IL41x, BRT2x, VO41xx, VO306x OptoTRIACs green production line transfer

Product Change Notification

Product Group: OPT/Thursday September 3, 2026/PCN-OPT-1495-2026-REV-1

PCN OPT-1495-2026 Package Dimensions Comparison

DIP-6

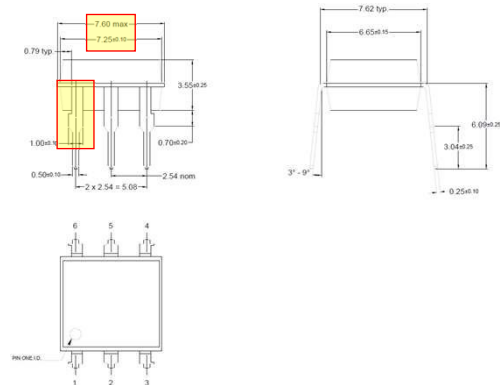
Note: major changes are the package length and the lead shape form
